TOLEDO - LUCAS COUNTY PLAN COMMISSIONS

REF: SUP-6010-22

SUBJECT: Amendment to a Special Use Permit originally granted by Ordinance 270-22, for parking lot and detention modifications.

LANDSCAPE PLAN

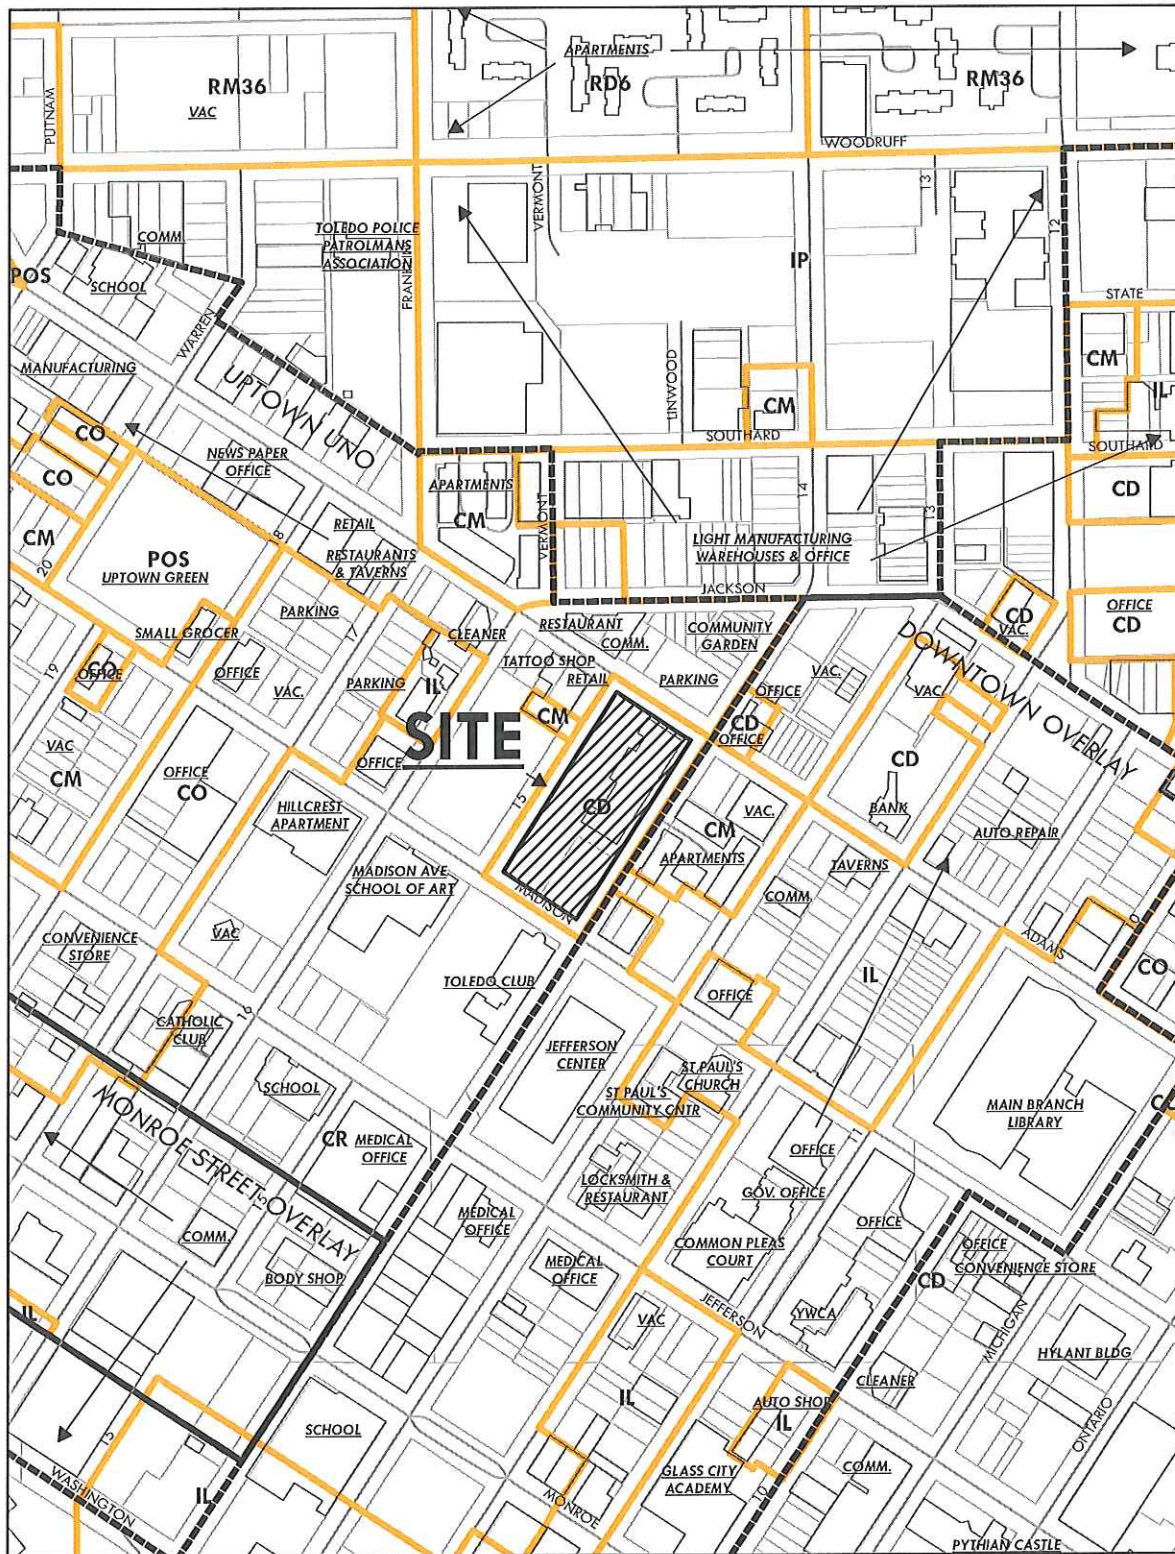
20. A parking stop or other sufficient method as approved by the Director of the Plan Commission to prevent vehicles from entering the stone verge for the bioretention area shall be required.
None depicted.

- f. Landscape requirements of Ordinance 772-22 must nonetheless be achieved per TMC§1108.0206(B)(1).
- g. Bioretention filter beds must be planted with turf, trees, and/or perennial plant material chosen from lists provided by the Rain Garden Initiative. **Mulch shown, plantings shall be added on revised landscape plan.**

LANDSCAPE PLAN
ID 9

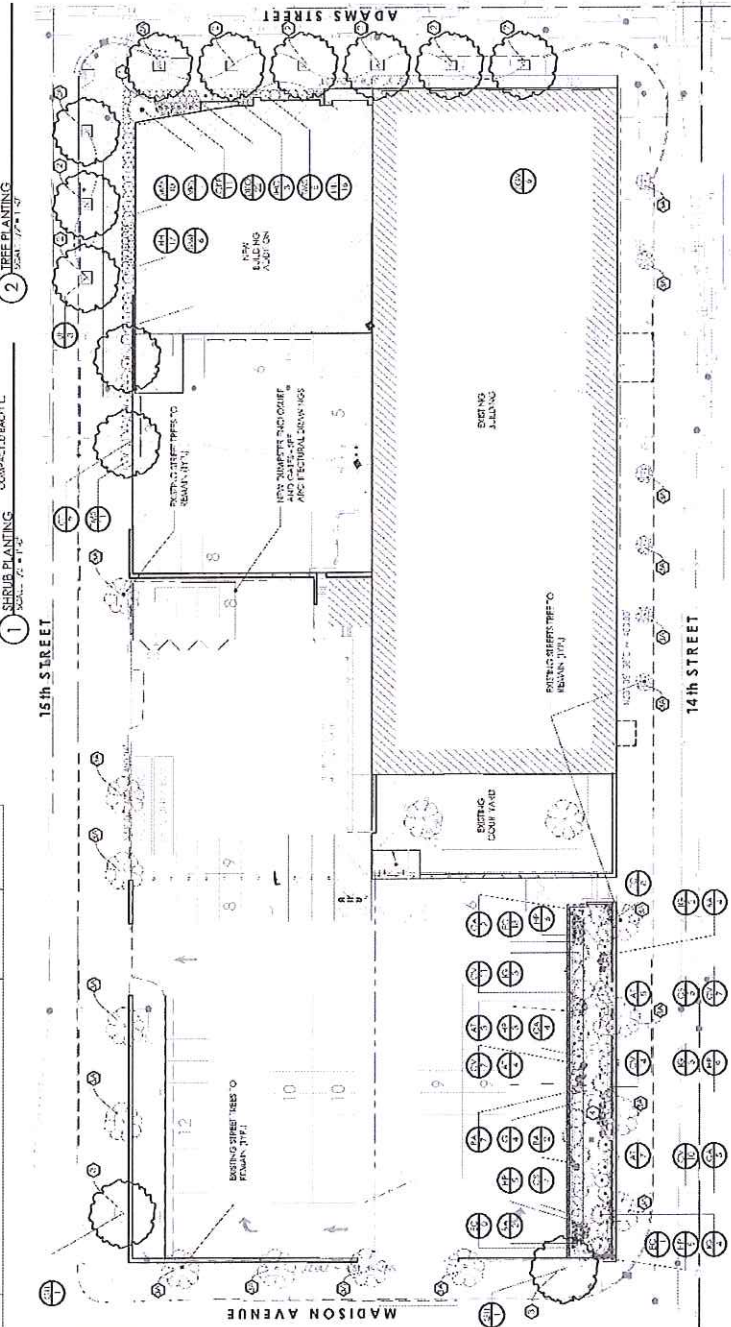
- a. The bio-retention facility must be designed to infiltrate to drain dry or have a bottom slope minimum of 1% to drain dry.
 - b. Side slopes shall have a maximum side slope no more than 3:1 (three units horizontal to one unit vertical).
